PLANNING AND DEVELOPMENT SERVICES STAFF REPORT

For Planning Commission Meeting of June 18, 2013

**SUBJECT: Hampton Inn Planned Project Site Plan for City Council Approval
(2910 Jackson Avenue)
File No. SP13-002**

Date:	01.07.13
Scale:	1" = 40'
Sheet:	LA-1
Project:	17485.01

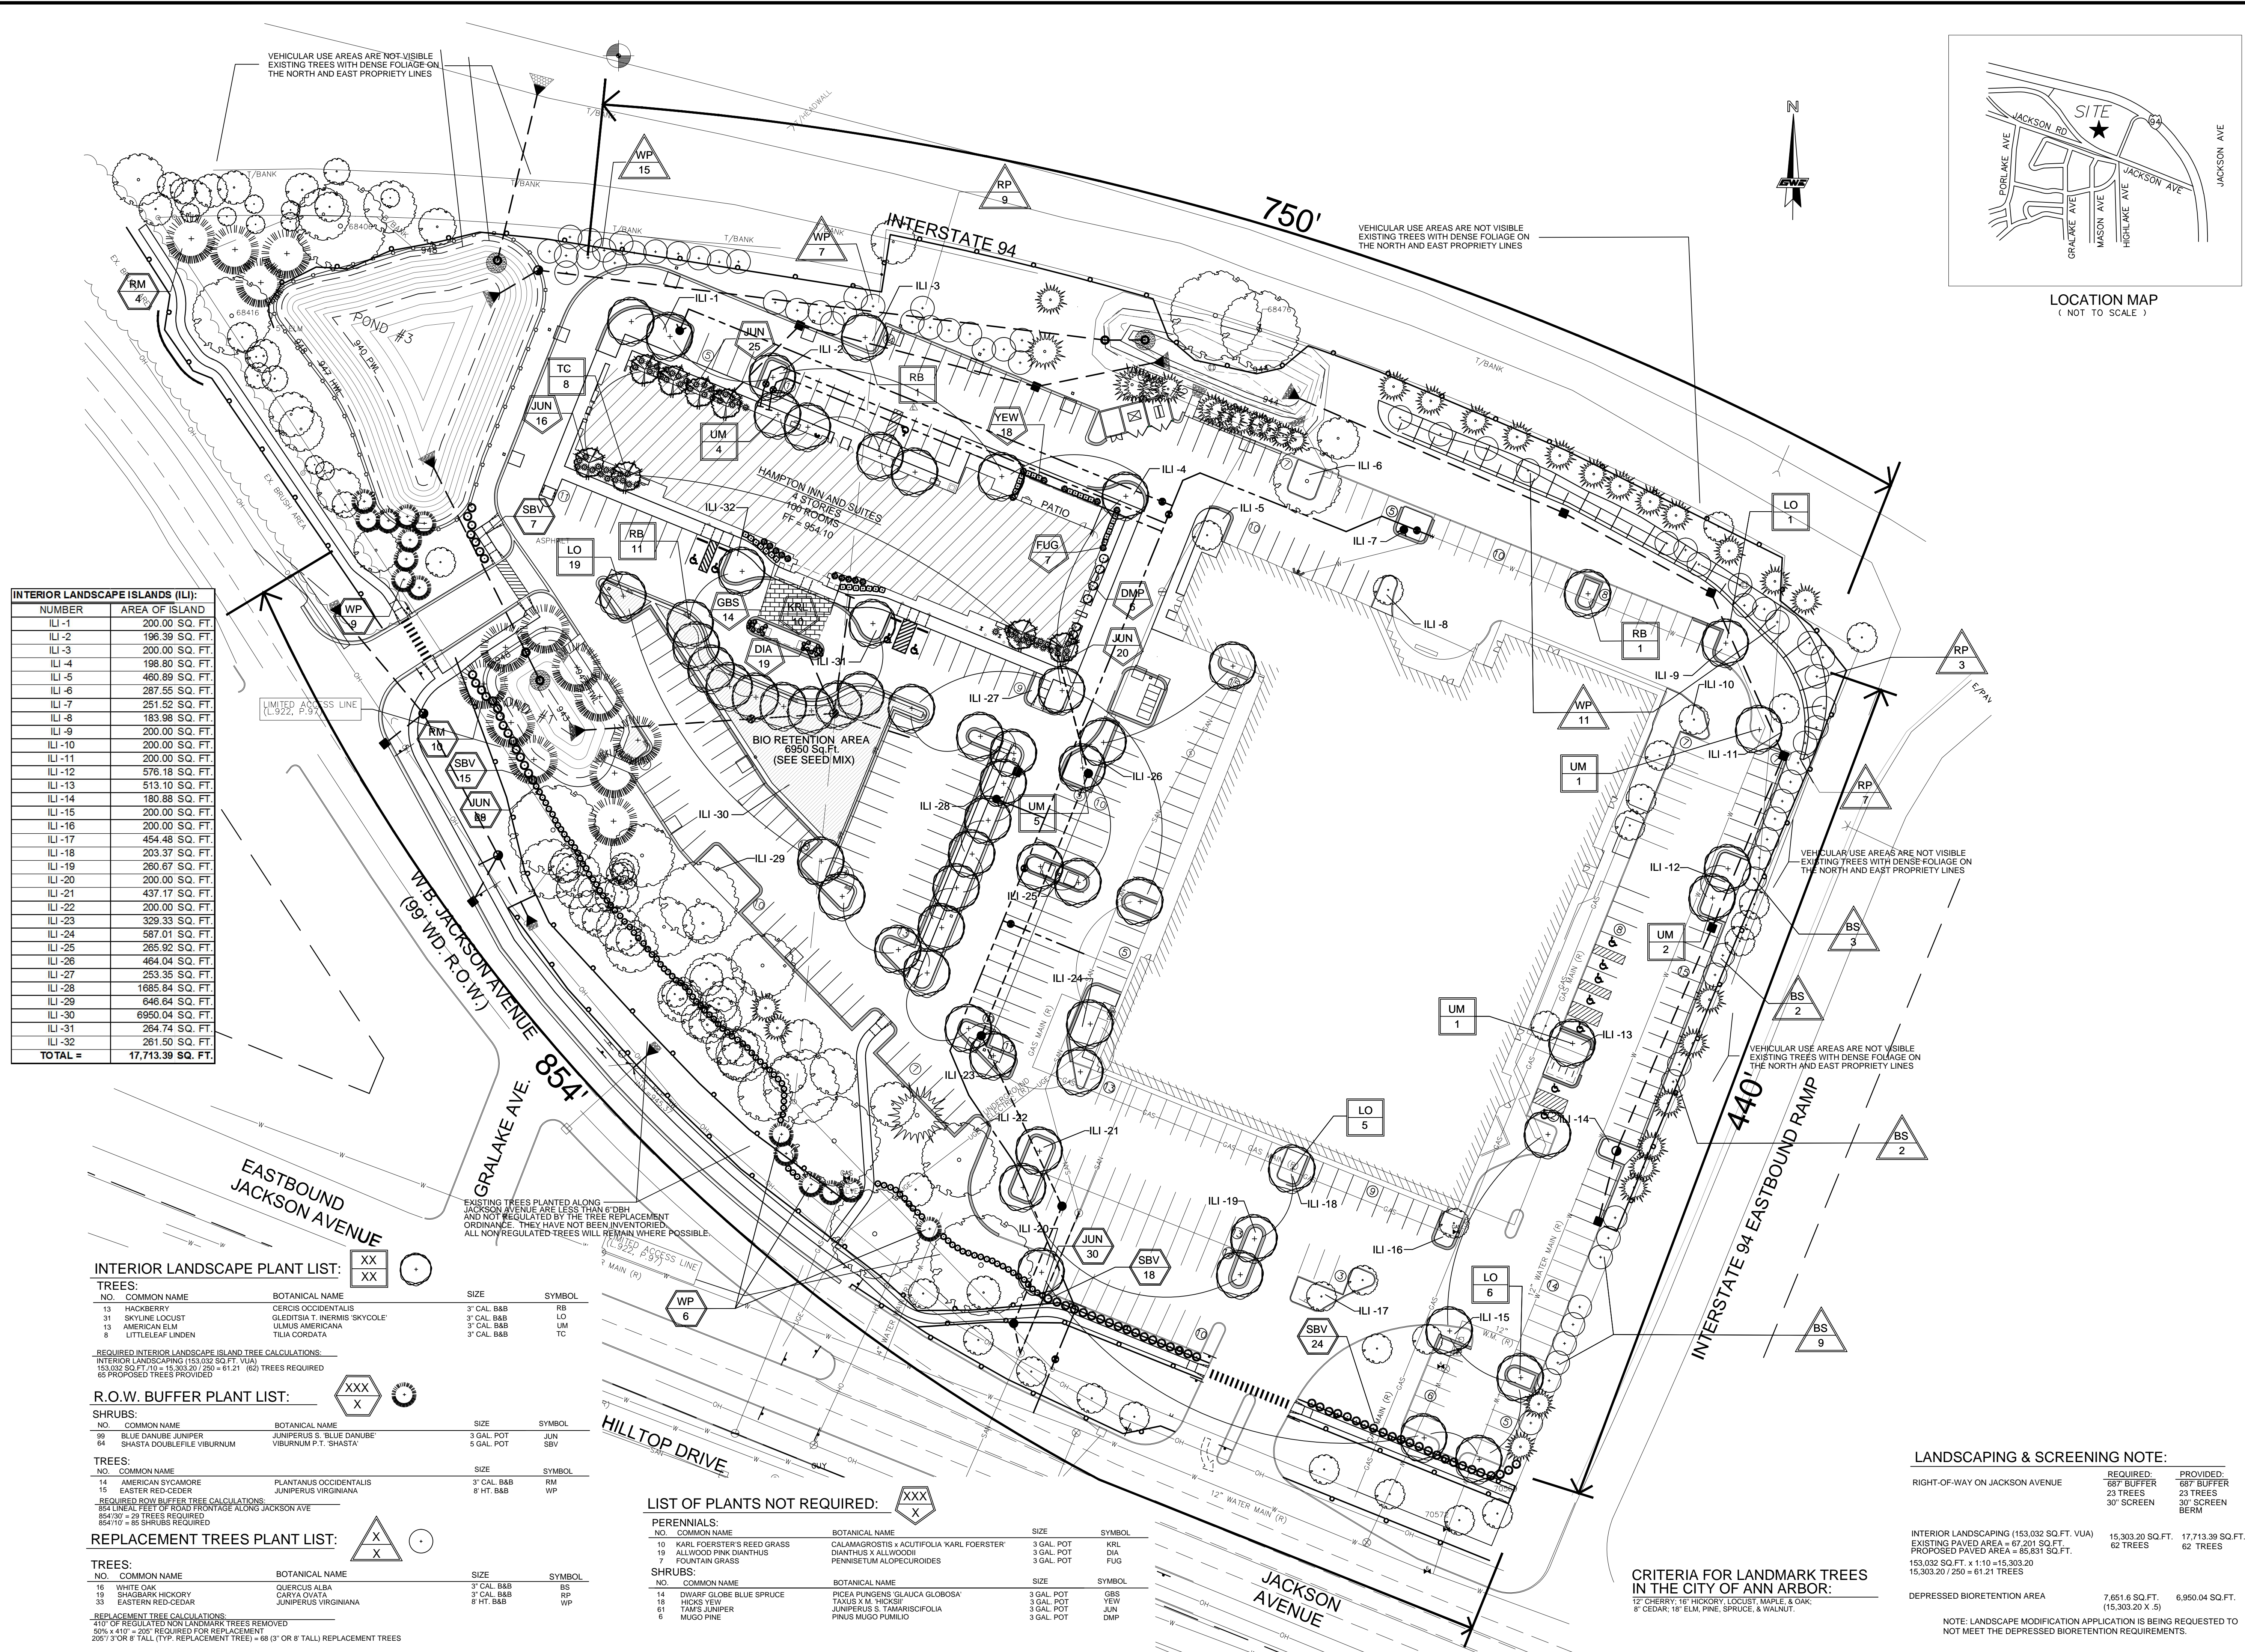
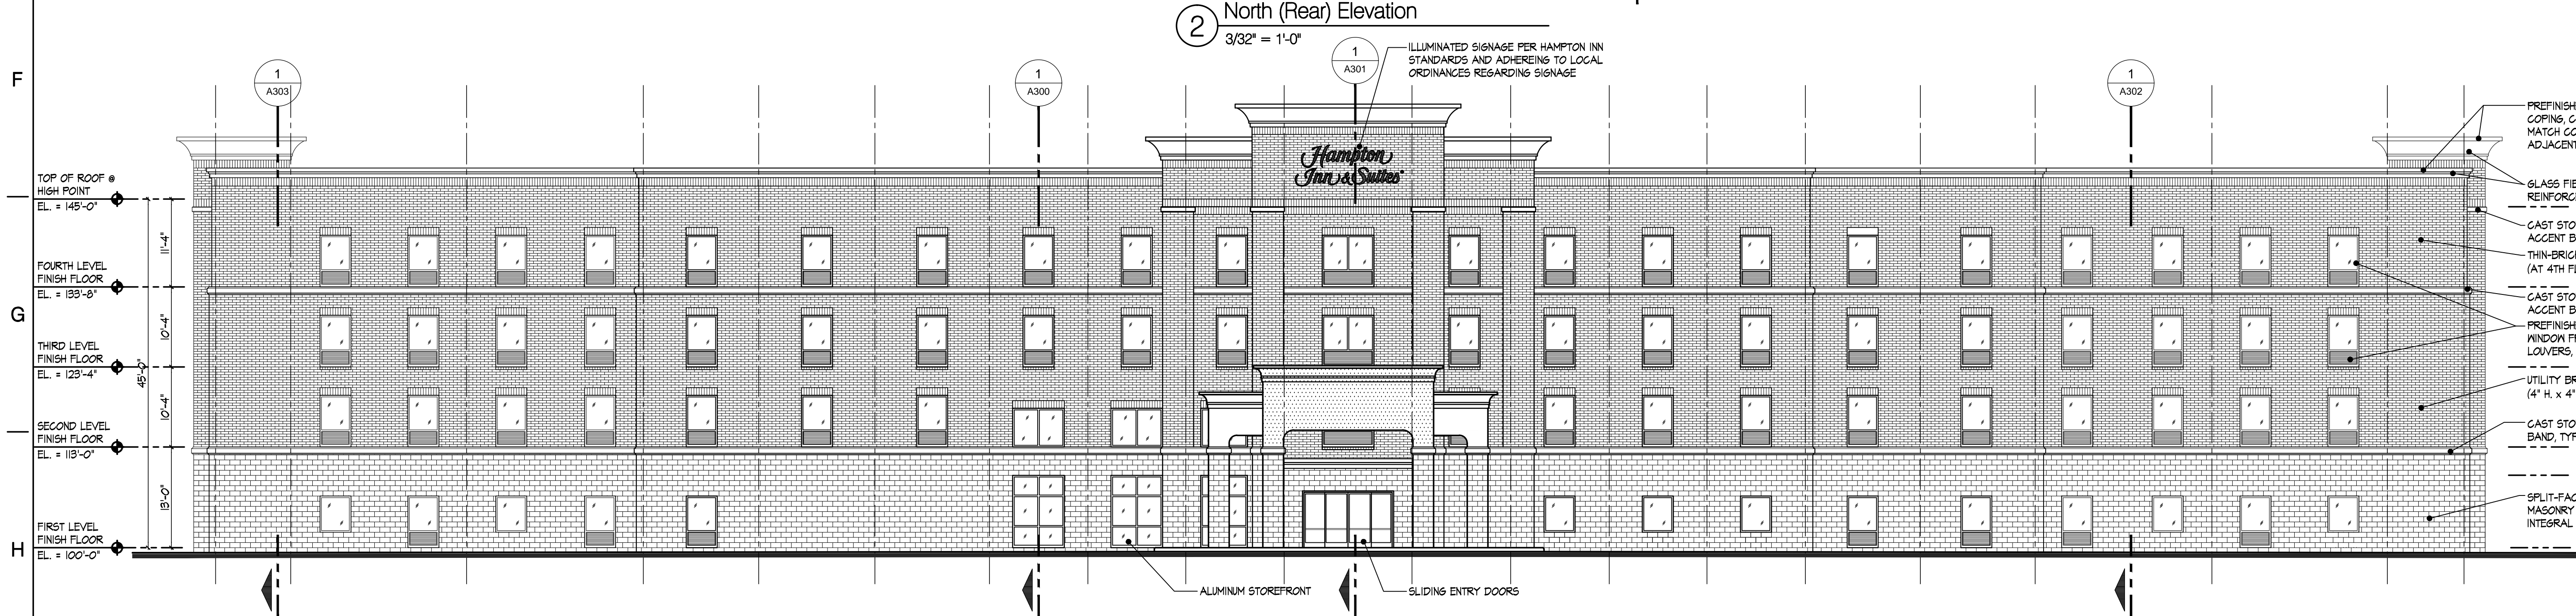
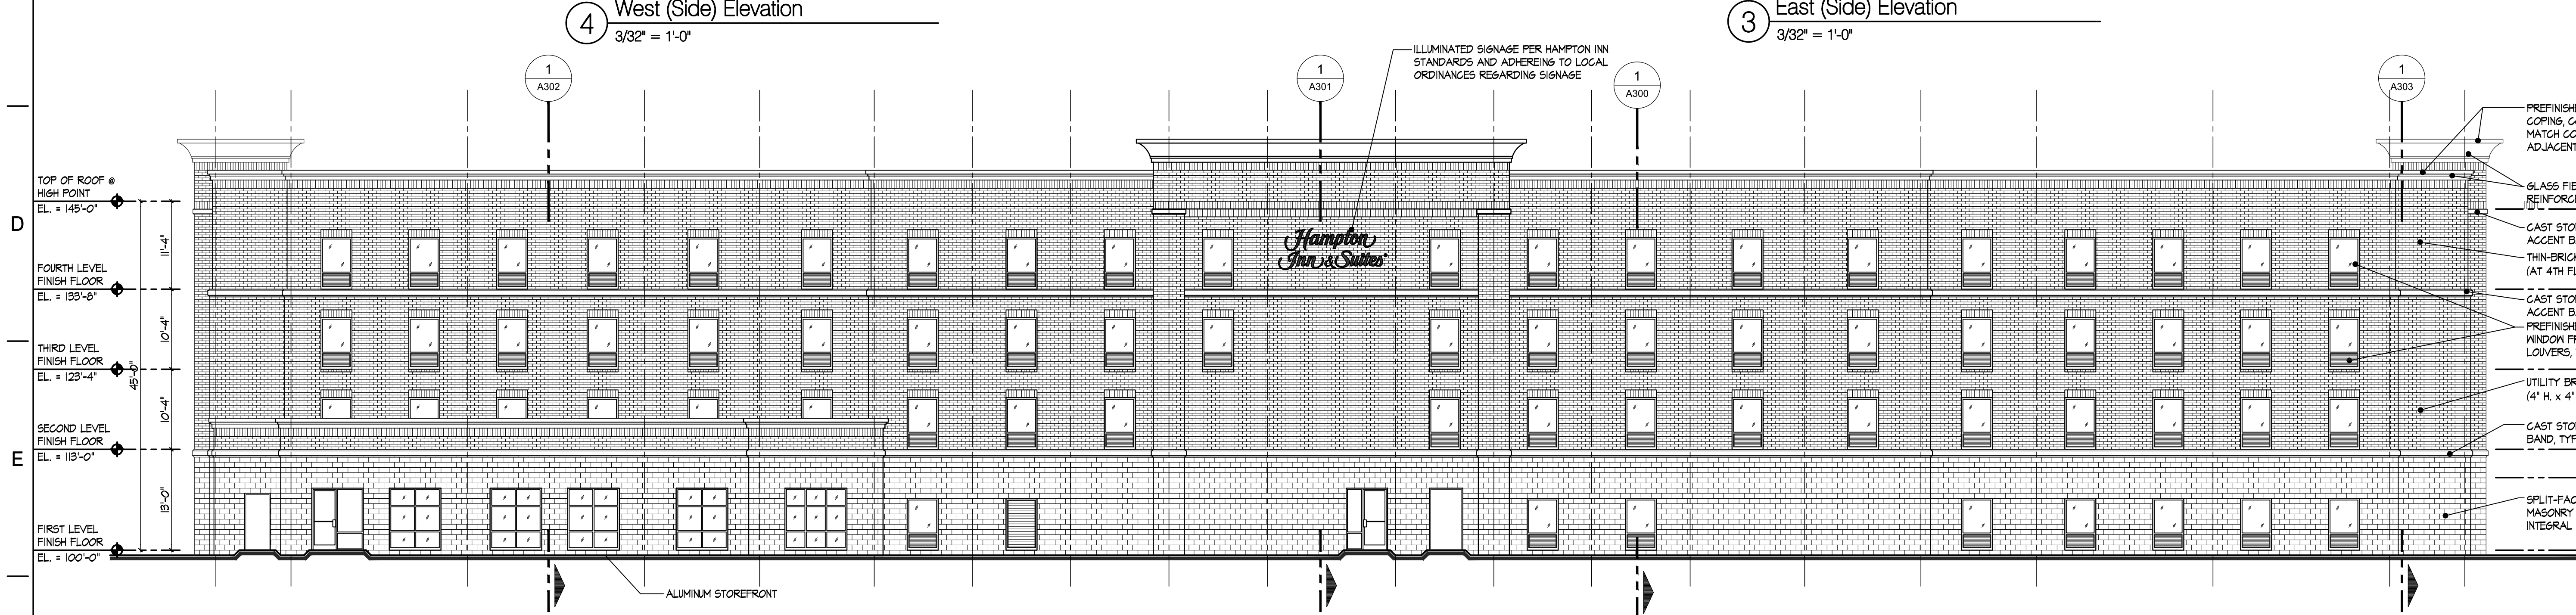
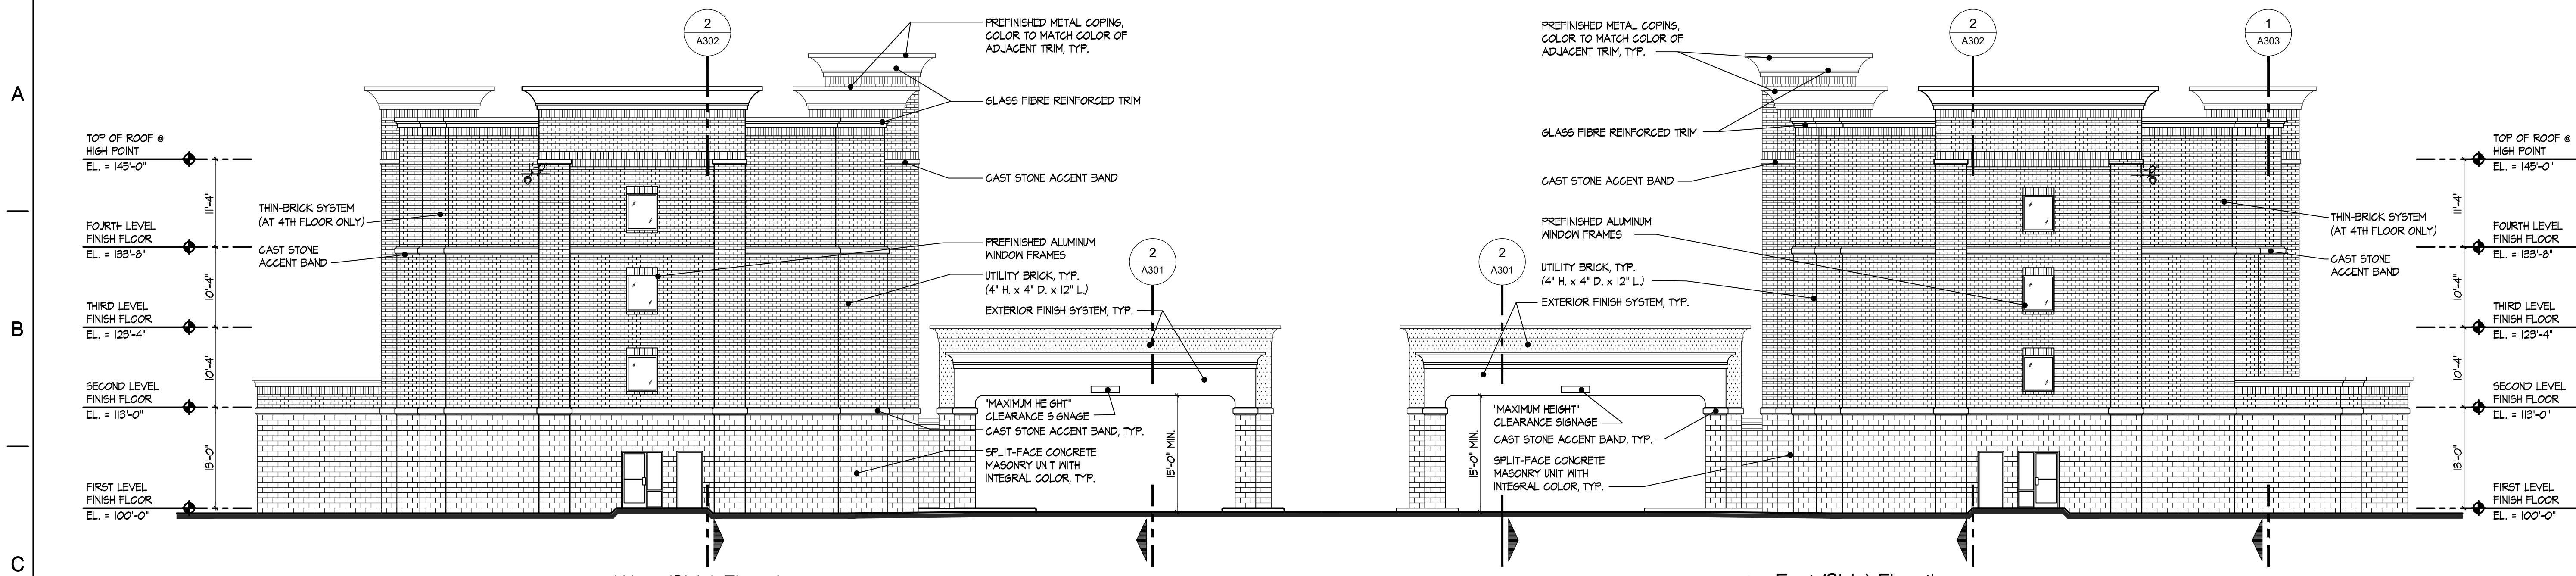
The petitioner has requested a modification of the requirement that when the total area required in interior landscape islands for all of the vehicular use areas on site exceeds 750 square feet, at least 50% of the required interior landscape area must be depressed bioretention areas and utilized for storm water management.

1. What are the specific site conditions that necessitate this request and how do they warrant the modifications of Chapter 62 requirements?

In order to reach the required 50% depressed bioretention area within the interior landscape islands, parking spaces would have to be removed or the depressed area would have to be split between multiple small areas. These multiple areas would prove difficult and inefficient to maintain. Furthermore, the large depressed open area is much more likely to take hold and be self-sustainable.

The area of the interior landscape islands is 17,713 square feet. The triangular bioretention area near the front door is 6,950 square feet, or 39% of the islands.

2. How does the proposal meet the spirit and intent of Chapter 62?

The most recent proposal has increased the overall green space on the site which in turn has increased the amount of landscaping for the project. While short of the required 50% depressed bio retention area, the site exceeds interior landscape square footage. Also, the landmark trees have been incorporated into the original design to reserve the natural beauty and history of the site.

Staff recommends **approval** of the landscape modification because the proposed single large bioretention area meets the spirit and intent of the interior landscape island bioretention requirements.

NOTE: LANDSCAPE MODIFICATION APPLICATION IS BEING REQUESTED TO NOT MEET THE DEPRESSED BIORETENTION REQUIREMENTS.
